UNITED STATES PATENT AND TRADEMARK OFFICE

APPLICATION NO.	FILING DATE	FIRST NAMED INVENTOR	ATTORNEY DOCKET NO.	CONFIRMATION NO.
10/038,264	01/03/2002	Seungbae Park	EN999048D	8328
41245	7590	07/29/2004	EXAMINER	
MARK LEVY & ASSOCIATES, PLLC PRESS BUILDING, SUITE 902 19 CHENANGO STREET BINGHAMTON, NY 13901			GARCIA, ERNESTO	
			ART UNIT	PAPER NUMBER
			3679

Office Action Summary

DETAILED ACTION

FIG. 2

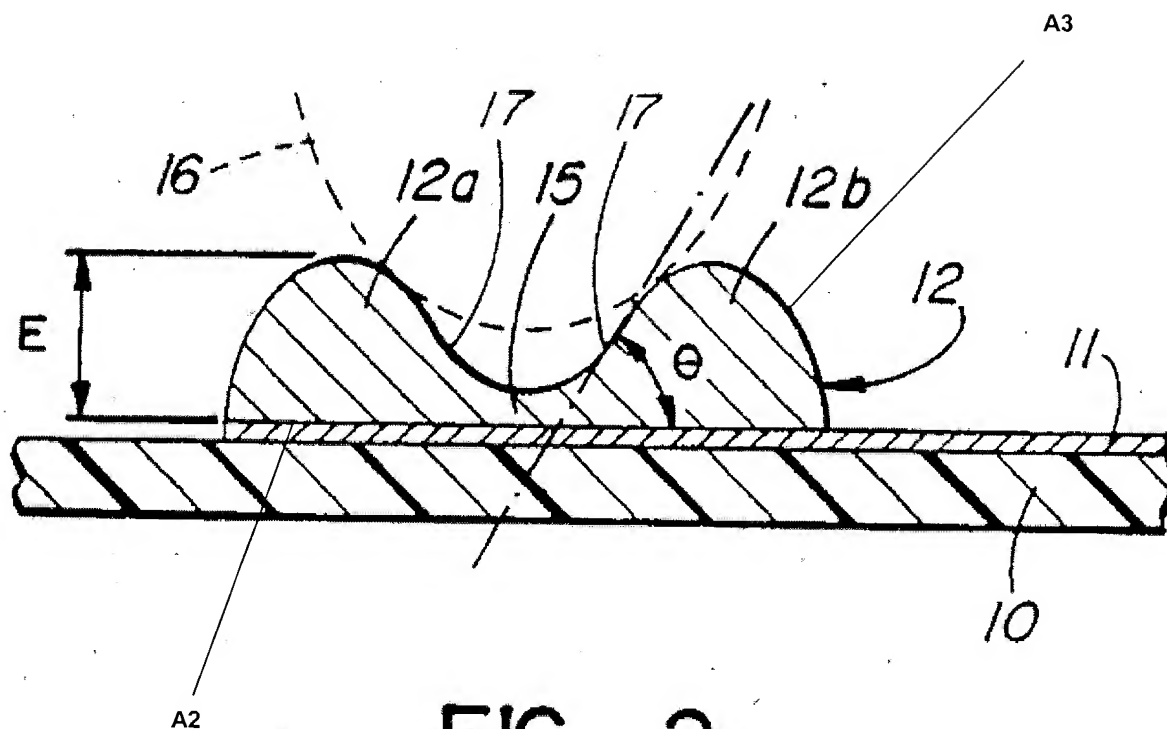
Regarding claim 9, Van Den Brekel et al., disclose, in Figure 2, a solder configuration comprising a pad **12** having a substantially planar lower surface **A2**, and a upper surface **A3**. The upper surface **A3** is characterized as substantially completely

non-planar-and-circuitous. Applicant is reminded that the recitation that an element is "adapted to" perform a function is not a positive limitation but only requires the ability to so perform. It does not constitute a limitation in any patentable sense. *In re Hutchison*, 69 USPQ 138. Therefore, the upper surface can be adapted to receive solder thereby forming a solder boundary portion of a solder joint, whereby, a crack, forming in the solder proximate the solder boundary, is influenced to proceed in a direction substantially parallel to the upper surface thereby lengthening its travel, and increasing fatigue life of the solder joint.

Regarding claim 10, a solder configuration comprising a pad **12** having a substantially planar lower surface **A2**, and an upper surface **A3**. The upper surface **A3** is characterized as substantially completely non-planar serpentine surface. Applicant is reminded that the recitation that an element is "adapted to" perform a function is not a positive limitation but only requires the ability to so perform. It does not constitute a limitation in any patentable sense. *In re Hutchison*, 69 USPQ 138. Therefore, the upper surface can be adapted to receive solder thereby forming a solder boundary portion of a solder joint, the solder boundary portion defining an intermetallic region extending therefrom and penetrating both the solder and the upper surface, whereby, a crack, forming in the solder proximate the solder boundary and within the intermetallic region, is influenced to proceed in a direction substantially parallel to the upper surface along a non-planar, serpentine path, thereby lengthening its travel, and increasing fatigue life of the solder joint.

Regarding claim 16, Van Den Brekel et al., disclose, in Figure 2, an improvement comprising a solder pad **12**, on a substrate **11**, having a substantially planar lower surface **A2** disposed on the substrate **11** and an upper surface **A3** characterized as substantially completely non-planar and circuitous. Applicant is reminded that the recitation that an element is "adapted to" perform a function is not a positive limitation but only requires the ability to so perform. It does not constitute a limitation in any patentable sense. *In re Hutchison*, 69 USPQ 138. Therefore, the upper surface can be adapted to receive solder, such that when solder is applied thereto so as to form a solder joint any crack in the solder proximate the upper surface of the solder pad is influenced to proceed along a path substantially conforming to the non-planar and circuitous upper surface, thereby lengthening its travel, and preventing failure of the solder joint.
